APPLICATION NO.	FILING DATE	FIRST NAMED INVENTOR	ATTORNEY DOCKET NO.	CONFIRMATION NO.
10/829,356	04/22/2004	Neil Aubrey Tarr	PAT 993-2 US	6065

Office Action Summary

DETAILED ACTION

Fig. 9: Westra (6,434,902)

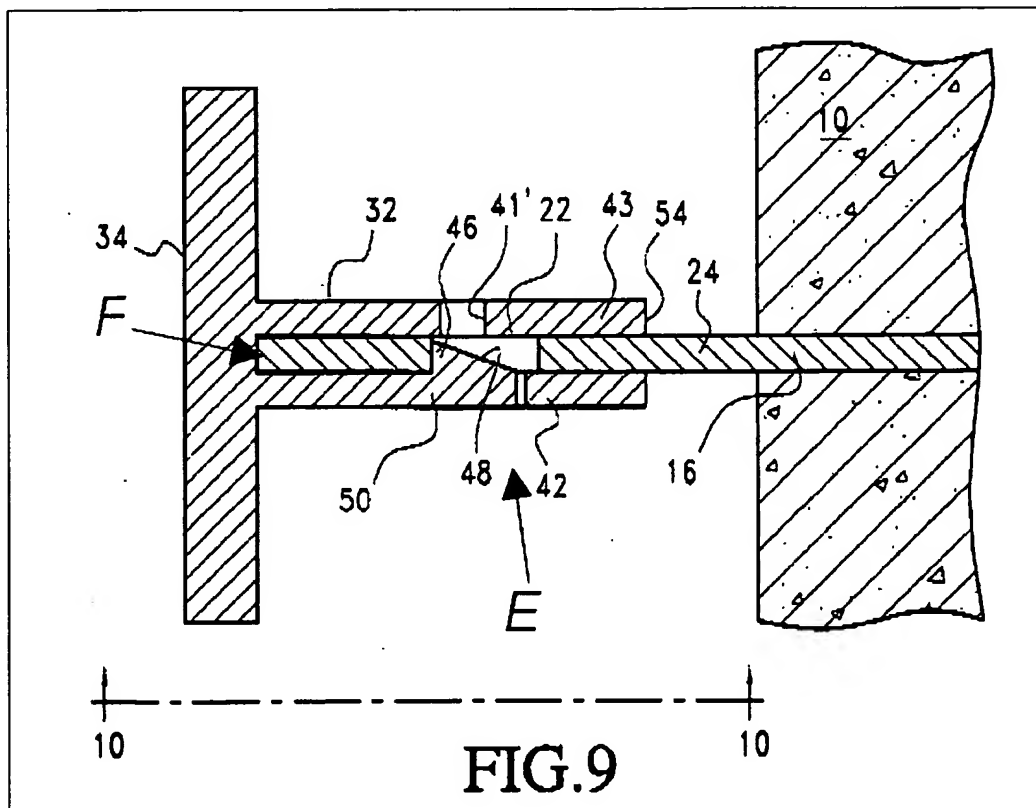
Alternatively, claims 1 and 4-5 are rejected under 35 U.S.C. 103(a) as being unpatentable over Westra (US 6,434,902).

With regards to claim 1: Westra discloses a stud (16) compositing:

- An anchoring system (E) (fig. 9) capable of anchoring the first surface to a form tie protruding from the concrete wall; and
- A lateral web (42, 43) extending from the first surface (54) (fig. 9) capable of receiving and retaining insulation adjacent to the concrete wall.

Westra does explicitly disclose a first surface (54) capable of abutting against a concrete wall (fig. 9). However, Westra discloses that first surface (54) does not necessarily need to be in contact with the wall for positive securement, but it possible and known in the art (col. 4, lines 4-14). In addition, Westra discloses an embodiment (as shown in fig. 8) where the first surface (D) abuts the concrete wall (10). Therefore, it would have been obvious to one of ordinary skill in the art at the time of the invention was made to modify the stud of Westra (as shown in fig. 9) to have the first surface abut

against a concrete wall as taught by Westra in order provide a stud with increased structural integrity and stability.

With regards to claim 4: Westra further discloses the anchoring system (A) includes a form tie receptacle (F) and an anchor (46) capable of engaging a hole in the form tie as per the modification above.

With regards to claim 5: Westra further discloses the anchor is a tab located with the receptacle (F) as per the modification above.
